ADDENDUM NO. 4
September 5, 2024

Customs and Border Protection (CBP) Federal Inspection Service (FIS) Facility Renovation
City of Duluth Project No. 24-4401
Duluth International Airport
Duluth, MN

SEH No. DULAI 170389

FIRST LEVEL ELECTRICAL DEMOLITION PLAN - AREA A

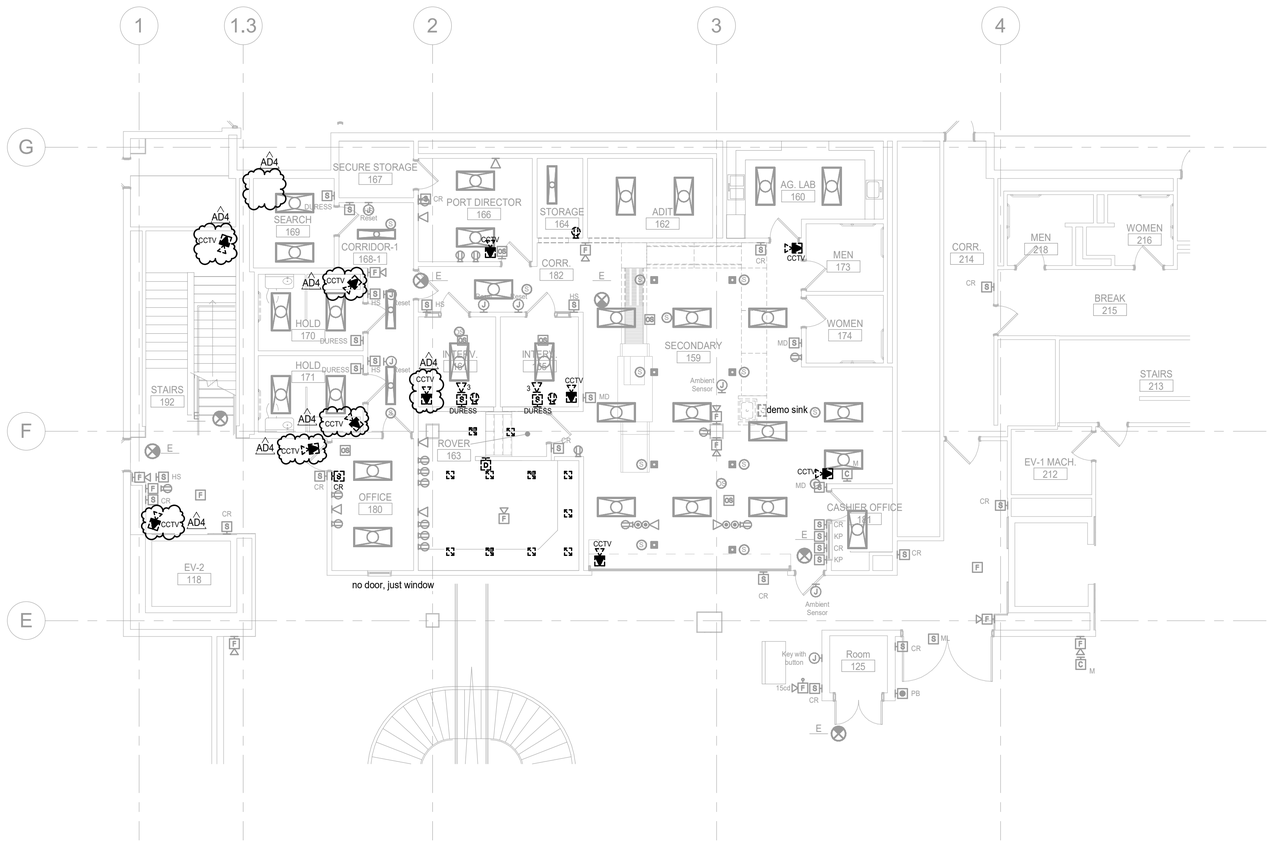
1. ED100 – FIRST LEVEL ELECTRICAL DEMOLITION PLAN – AREA A
   a) Revised location of (2) demolished cameras.
   b) Demolished (4) existing cameras.
   c) Removed demolition of (1) camera in Search 169.

SECOND LEVEL
ELECTRICAL DEMOLITION
PLAN - AREA A

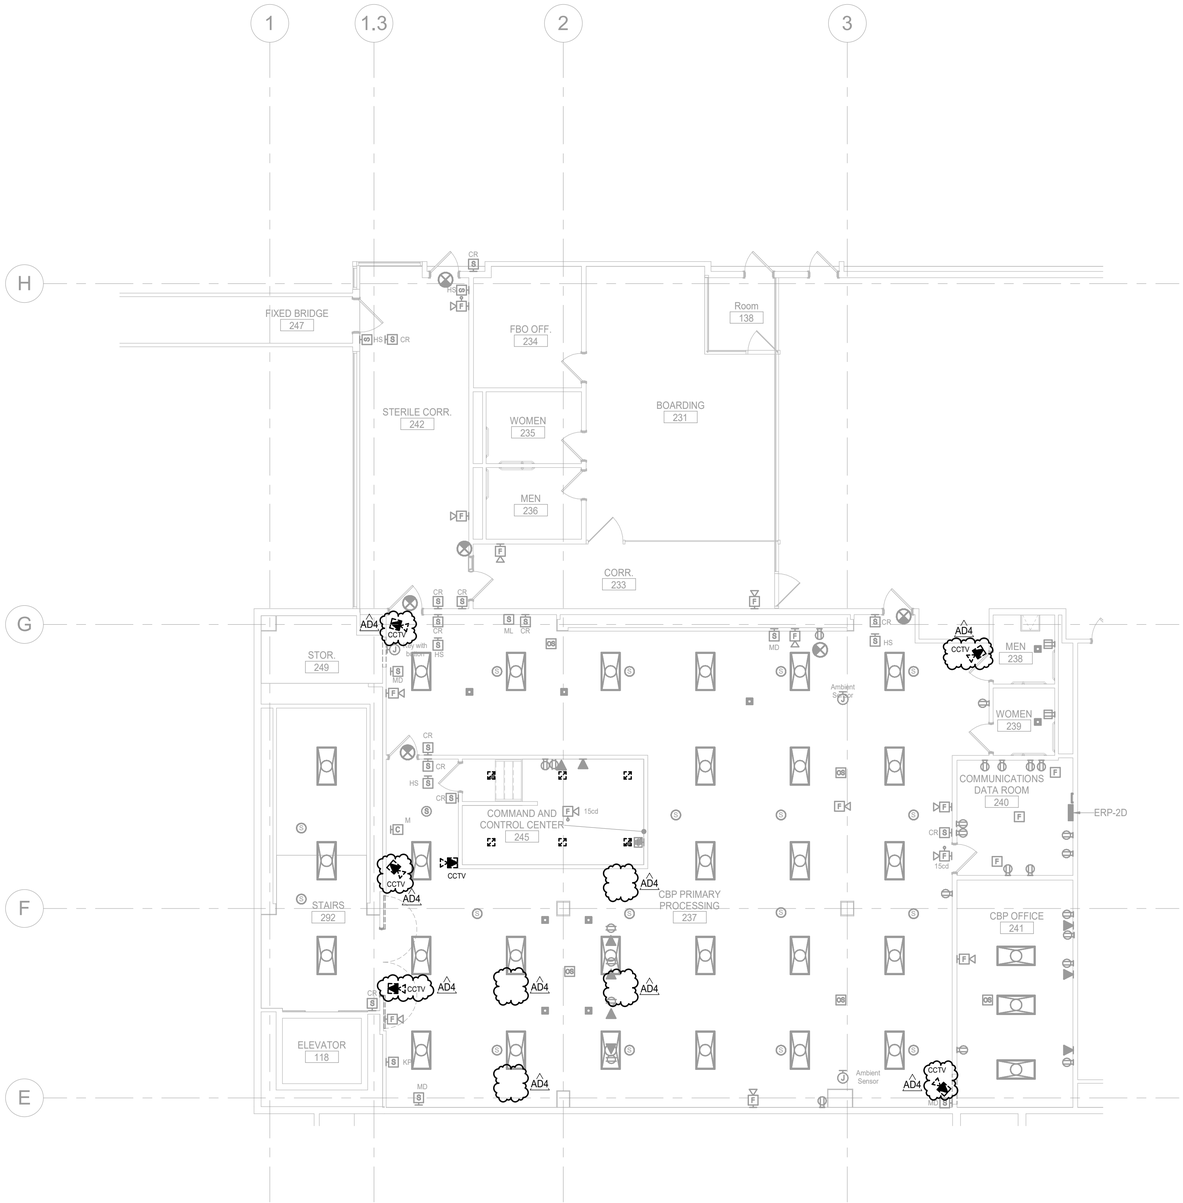
2. ED200 – SECOND LEVEL ELECTRICAL DEMOLITION PLAN – AREA A
   a) Demolished (5) existing cameras.
   b) Removed demolition of (4) cameras.
3. E100 – FIRST LEVEL ELECTRICAL FLOOR PLAN – AREA A

FIRST LEVEL ELECTRICAL FLOOR PLAN - AREA A

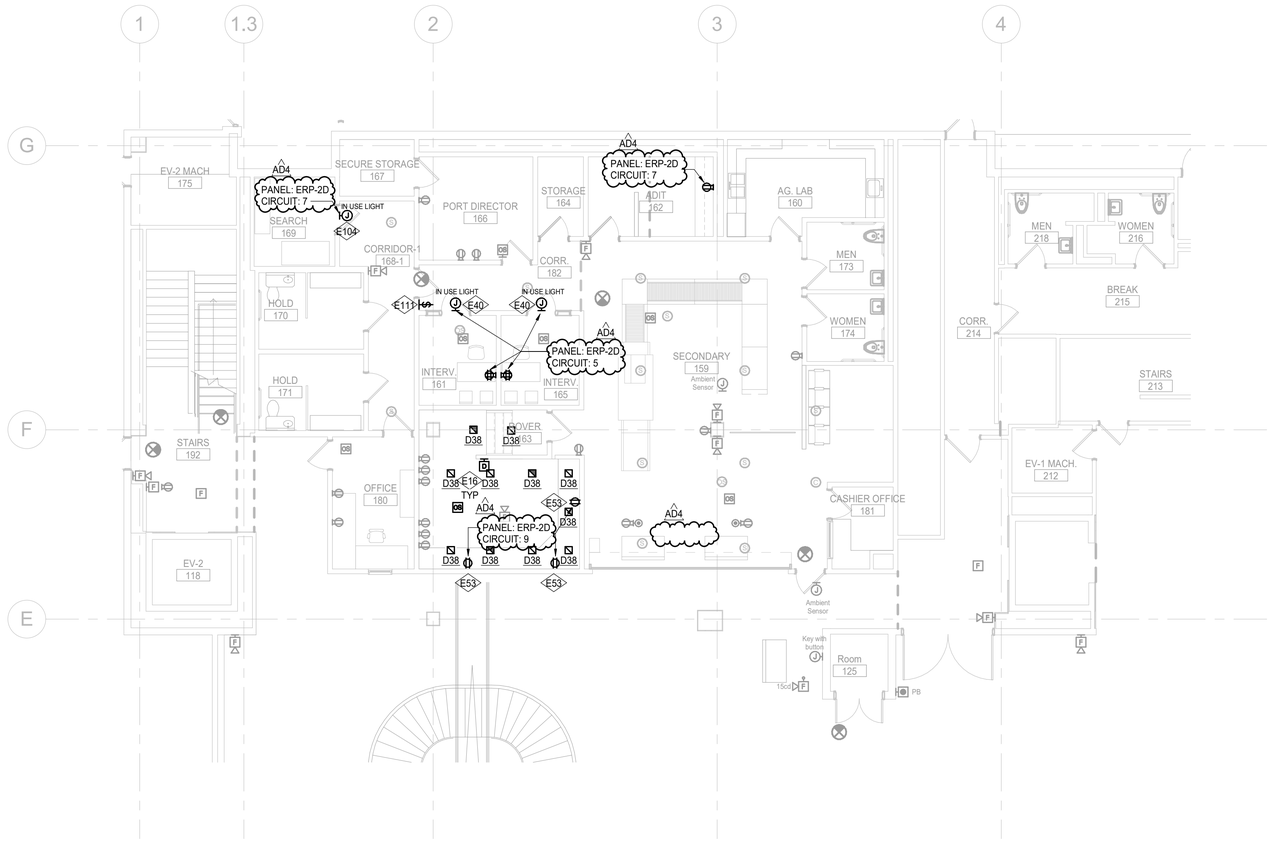
a) Removed (2) power pole and receptacles for Secondary podiums.
   b) Revised panel for (3) new branch circuits.
4. E200 – SECOND LEVEL ELECTRICAL FLOOR PLAN – AREA A

SECOND LEVEL ELECTRICAL FLOOR PLAN - AREA A

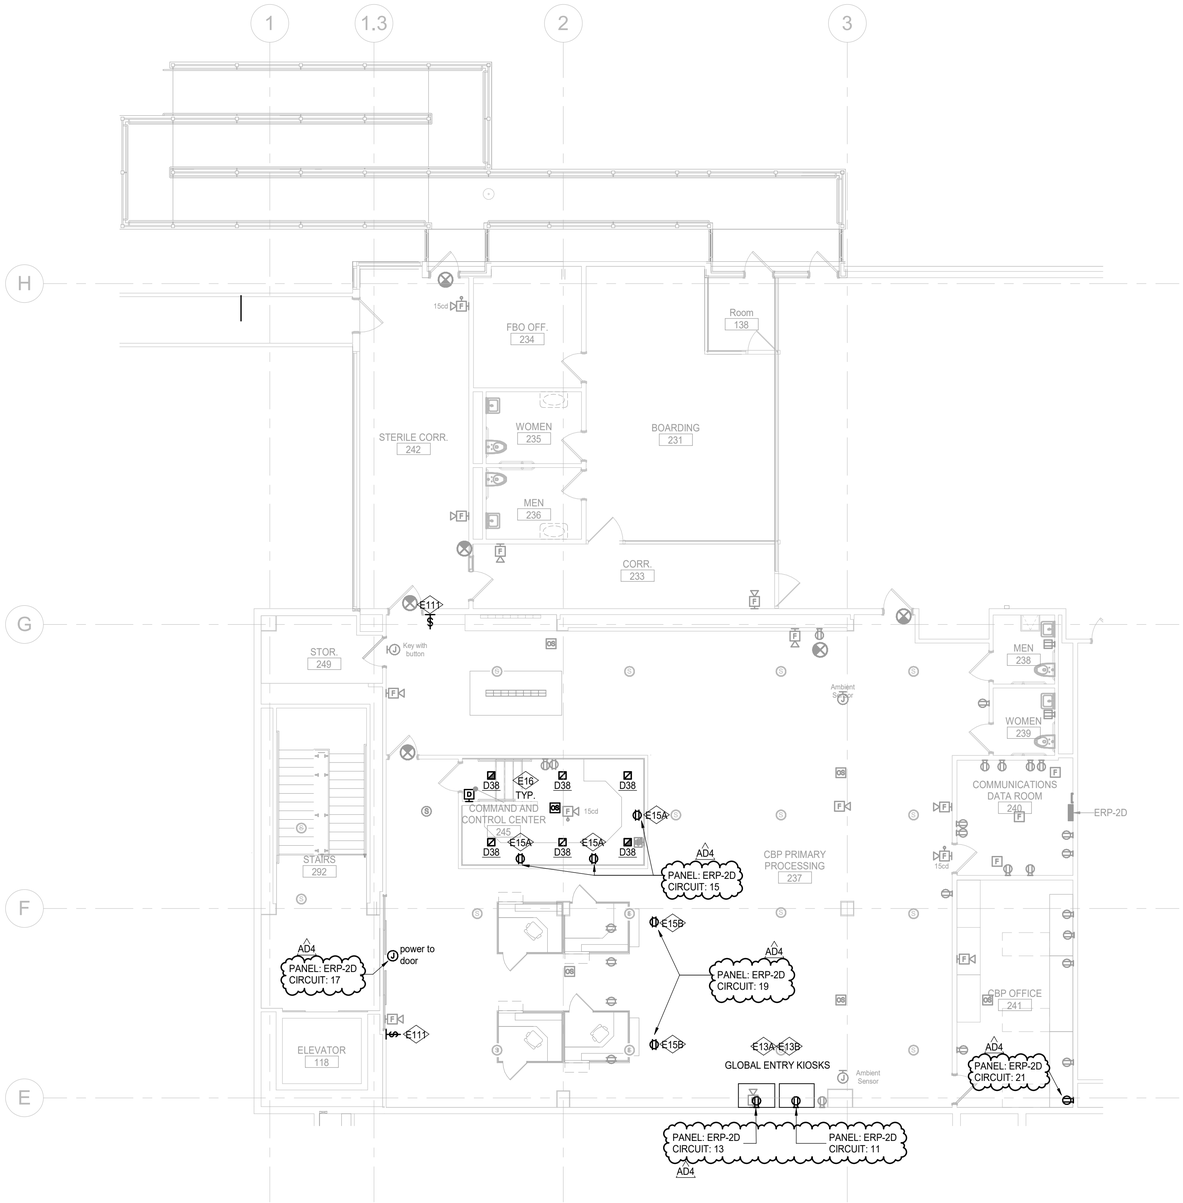
a) Revised panel for (5) new branch circuits.
5. E300 – ELECTRICAL SCHEDULES
   a) Replaced RP-1C panel schedule with panel ERP-2D.
6. S100 – FIRST LEVEL SECURITY FLOOR PLAN – AREA A

FIRST LEVEL SECURITY FLOOR PLAN - AREA A

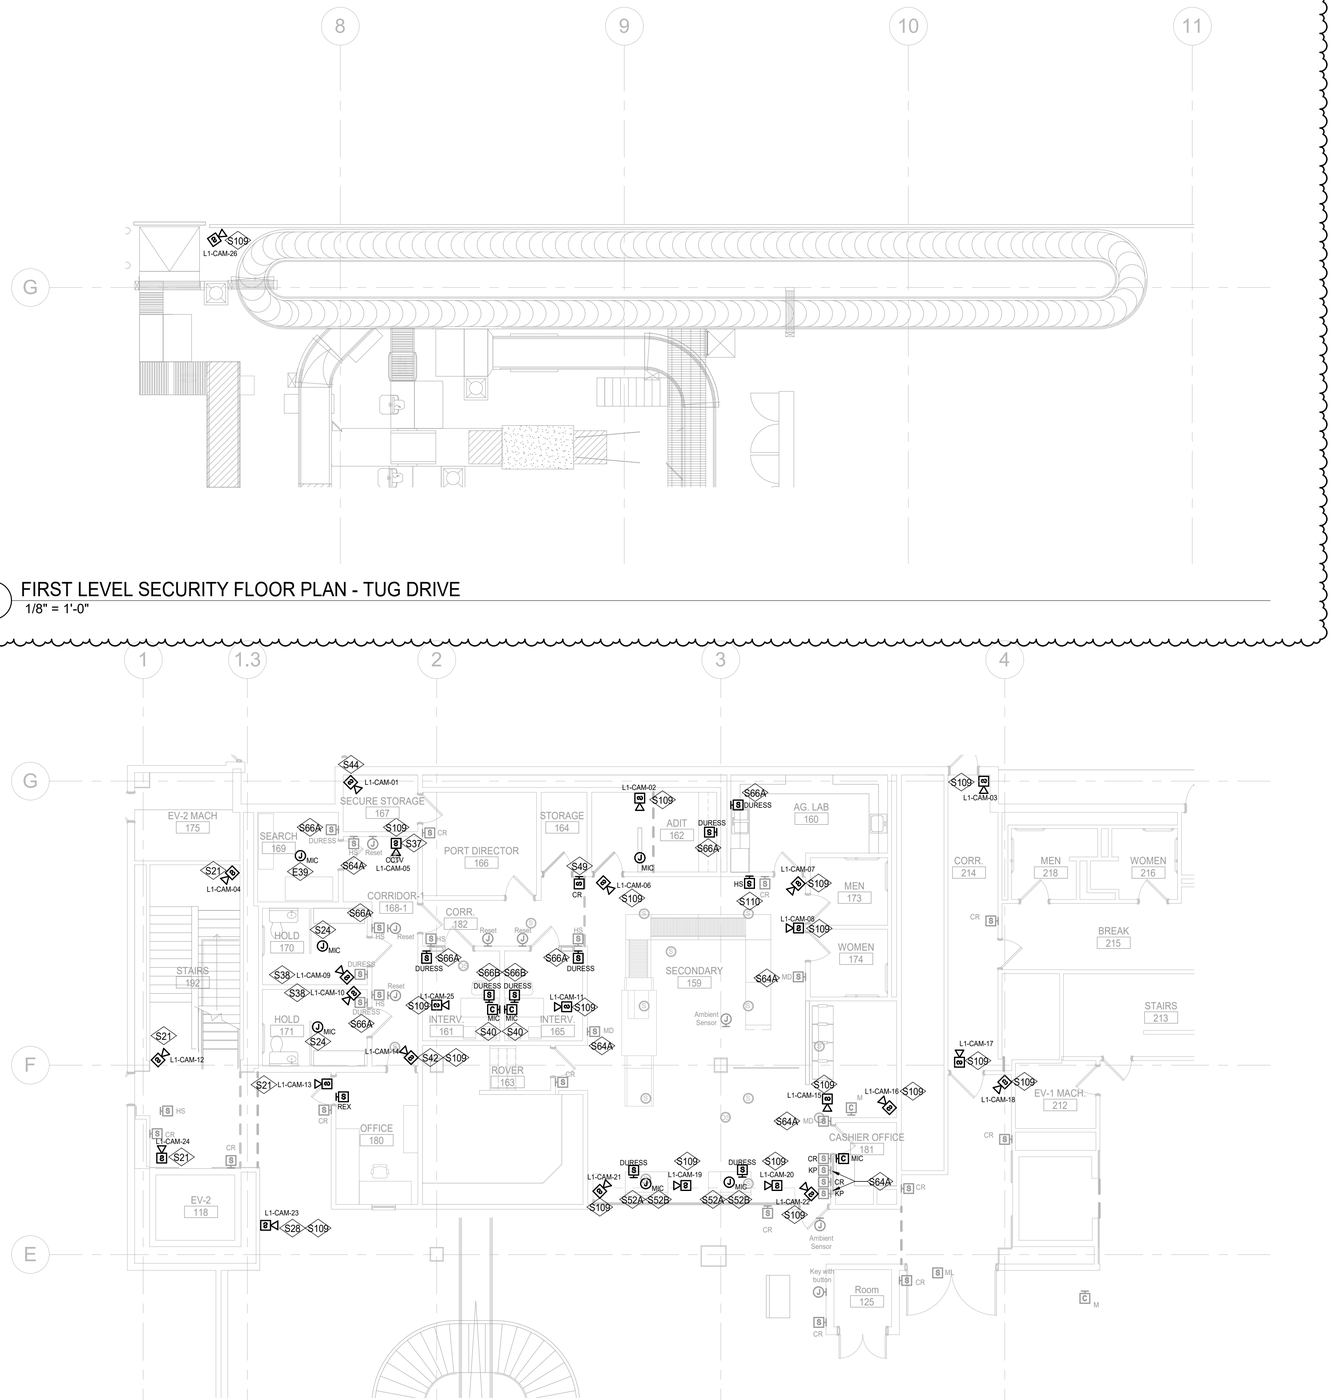
a) Revised keynotes S3B, S4, S5A, S5B, S5C, S49, S52B, and S110.
   b) Removed keynote S77.
   c) Added keynote S111.
   d) Added view for the tug drive.

e) Added (1) new camera in the tug drive.
7. S200 – SECOND LEVEL SECURITY FLOOR PLAN – AREA A
   a) Revised keynotes S3B, S4, S5A, S5B, S5C, S49, S52B, and S110.

SECOND LEVEL SECURITY FLOOR PLAN - AREA A

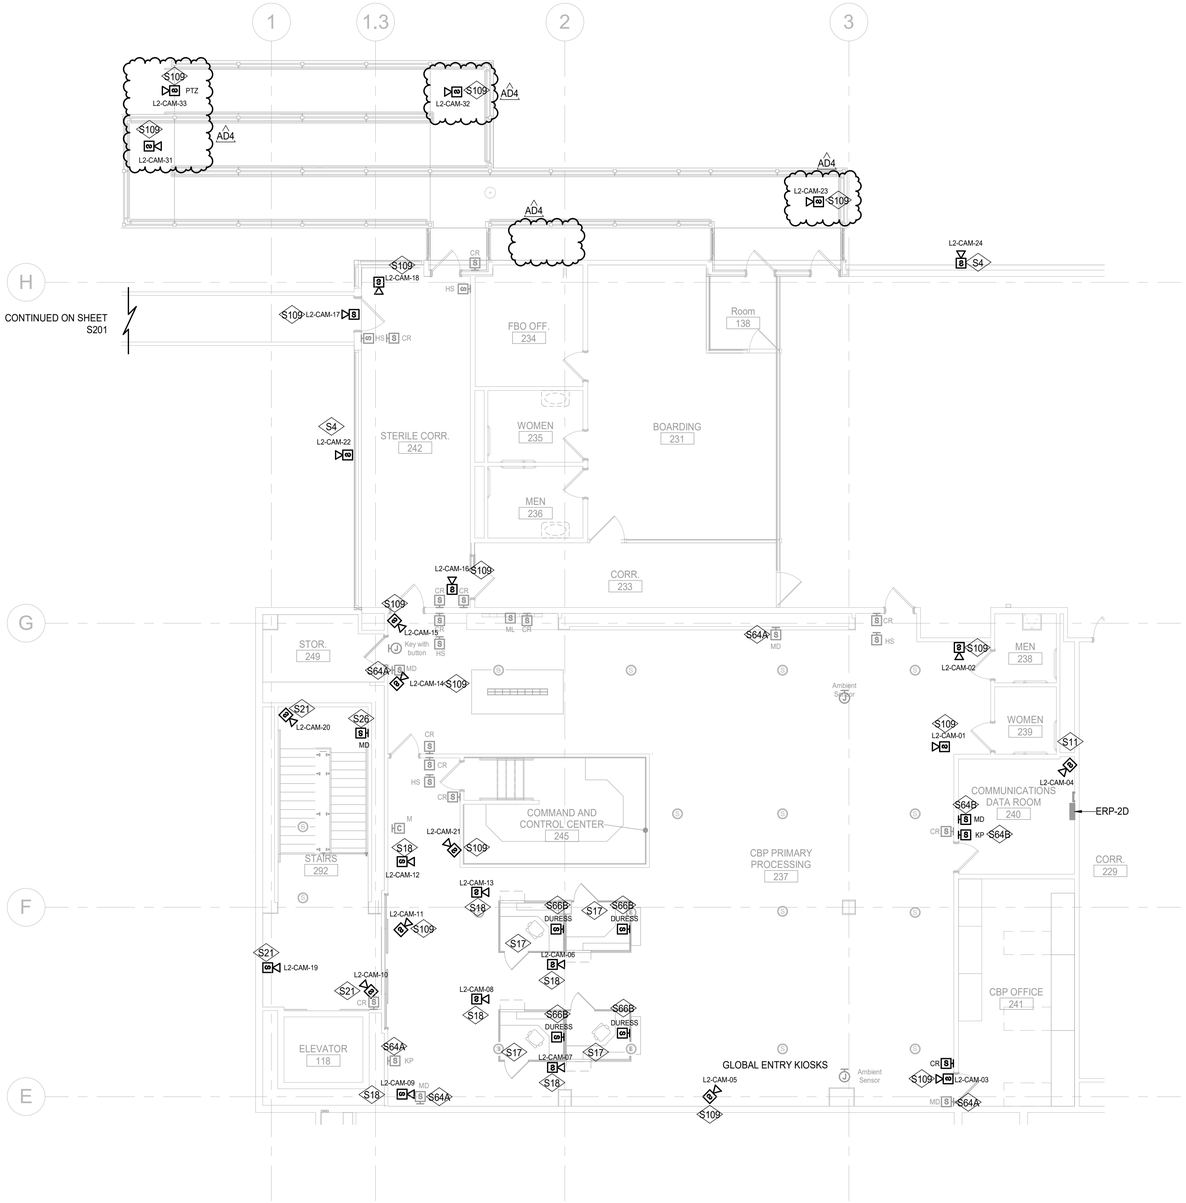
c) Added keynote S111.
d) Moved (1) new camera onto the passenger ramp.
e) Added (2) new fixed cameras to the passenger ramp.
f) Added (1) new PTZ camera to the passenger ramp.

SECOND LEVEL SECURITY FLOOR PLAN - PASSENGER BOARDING BRIDGE

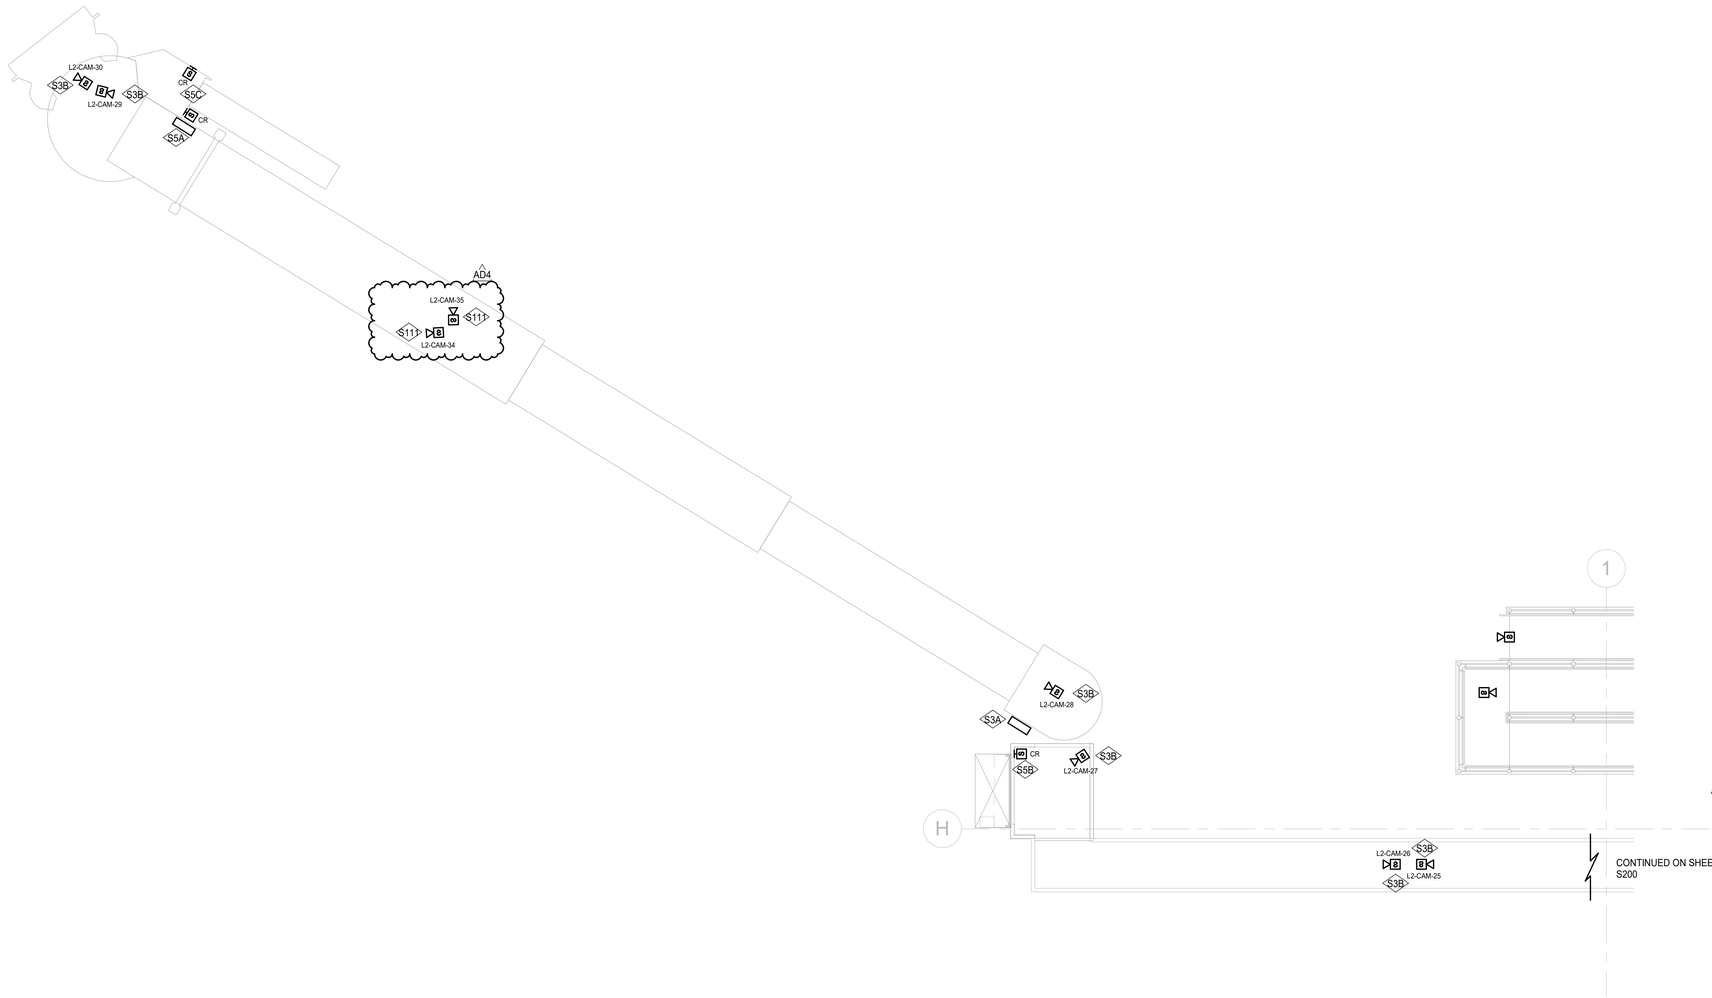
8. S201 – SECOND LEVEL SECURITY FLOOR PLAN – PASSENGER BOARDING BRIDGE
   a) Revised keynotes S3B, S4, S5A, S5B, S5C, S49, S52B, and S110.
   b) Removed keynote S77.

c) Added keynote S111.
   d) Added (2) new cameras underneath the passenger boarding bridge.
9. S300 – CAMERA SCHEDULE AND DETAILS
   a) Added new cameras to camera schedule.

FIRST LEVEL TELECOMMUNICATIONS FLOOR PLAN - AREA A

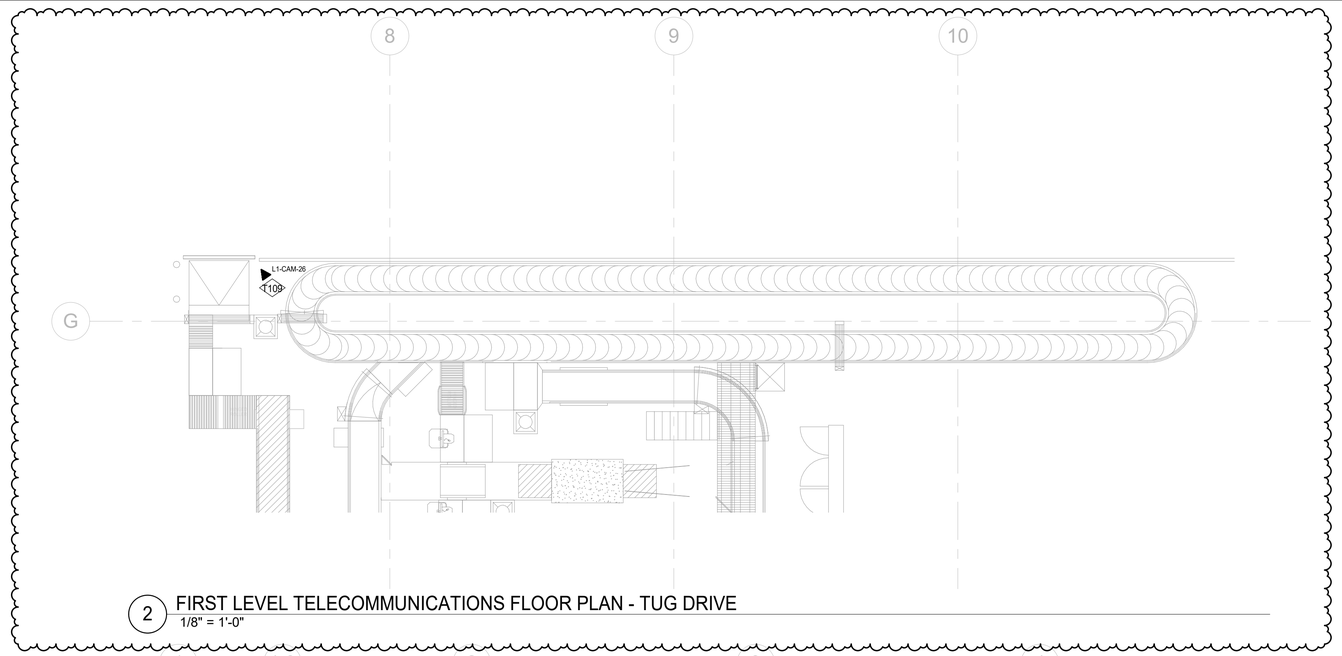
10. T100 – FIRST LEVEL TELECOMMUNICATIONS FLOOR PLAN – AREA A
    a) Removed (2) power pole and receptacles for Secondary podiums.
    b) Revised general notes.

c) Added view for the tug drive.
    d) Added (1) data for new camera in the tug drive.
11. T200 – SECOND LEVEL TELECOMMUNICATIONS FLOOR PLAN – AREA A
